UNITED STATES PATENT AND TRADEMARK OFFICE

10/651,115

Keith D. Mease

Office Action Summary

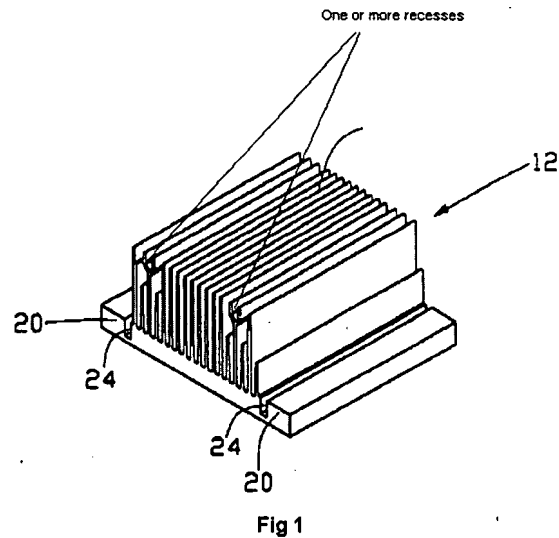
Claim 15 is rejected under 35 U.S.C. 102(b) as being anticipated by Lo (US 6,360,812).

With respect to claim 15, Lo further teaches a circuit board assembly comprising: a circuit board (80); a heat generating component mounted on said circuit board (Col: 2, Line 19); and a heat sink (12) thermally coupled to said heat generating component (Col: 2, Lines 18-20), the heat sink having a base (Bottom portion of 12) abutting the heat generating component and a plurality of fins (See Lo Fig 1) disposed on a surface of the base opposite the heat-generating component for dissipating heat, the plurality of fins having faces parallel to one another (See Lo Fig 1), said parallel faces of the fins defining a recess (See POA Fig 1 below) for supporting and guiding an edge of a circuit card, said recess extending parallel to the base and at least partially defined by at least one of said fins and by surfaces extending along a length of the fins parallel to the base (See Lo Fig 1), the recess having a depth smaller than the height of said fins (See Lo Fig 1).

**Fig 2**

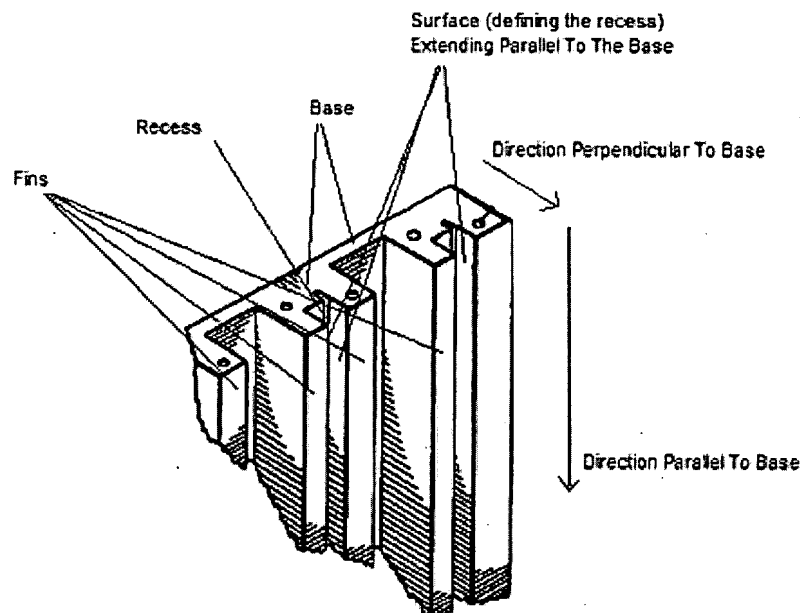
With respect to claim 1, Hughes et al. teaches a heat sink (10) configured to support an edge (82) of a circuit card (80), said heat sink comprising: a thermally conductive base (See present office action Fig 2 below); a plurality of thermally conductive heat dissipating fins (See POA Fig 2 below), extending perpendicularly from said base each fin having a length extending parallel to the base; and one or more recesses (16), each recess at least partially defined by adjacent parallel faces of two adjacent fins extending perpendicularly from said base, the recesses being defined in part by surfaces extending along the length of the fins parallel to the base, having a depth smaller than the height of said fins (See Fig 2, POA Fig 2 below), and being configured to support the edge of a circuit card (Column 3, Lines 55-57); and a face of the base disposed opposite said fins, said base being configured to be mounted with said face abutting a heat-generating component (See POA Fig 2 below, [it has been

held that the recitation that an element is "configured to" perform a function is not a positive limitation but only requires the ability to so perform and is therefore given little patentable weight. In *re Hutchison*, 69 USPQ 138.], wherein the base is configured to be mounted with the face abutting a heat-generating component).

With respect to claim 6, Hughes et al. further teaches each of said one or more recesses is further defined by said base (See POA Fig 2 above which details how the base rises perpendicularly to at least partially define the recess).

With respect to claim 18, Hughes et al. further teaches a heat sink (10) guiding one or more circuit cards (80) and transferring heat from one or more heat-generating components (Column 3, Line 62 – Column 4, Line 3), said heat sink comprising: a first surface (Base as illustrated in POA Fig 2 above) defining one or more slots (16) configured to guide an edge of a circuit card; a second surface (Adjacent 14) opposite the first surface, the second surface being configured to abut a heat-generating component; and heat dissipating fins (See POA Fig 2 above, also 14) thermally coupled to said first surface, said one or more slots at least partially defined by two adjacent parallel faces of said fins (See POA Fig 2 above), said one or more slots (16) being

defined in part by a portion of said first surface extending parallel to the base (See POA Fig 2 above), said slot having a depth smaller than the height of said fins (See Hughes Fig 2), said heat sink being configured to provide a thermal path from the heat-generating component to said fins via said second surface (Column 3, Lines 62 – Column 4, Line 3).

configured to be mounted with said face abutting a heat-generating component", the Examiner respectfully disagrees. As clearly disclosed in both the previous rejection and the rejection above, Hughes clearly teaches a base (See POA Fig 2 above) with first and second faces (where the first face is adjacent 16 and the second face is adjacent 14) where the second face is **configured** to be mounted with a heat-generating component. The Examiner respectfully notes that the claim does not require that a heat generating component be mounted with said face abutting a heat-generating component, rather that the face be configured to be mounted with said face abutting a heat-generating component. As per above, Hughes clearly teaches such a limitation.
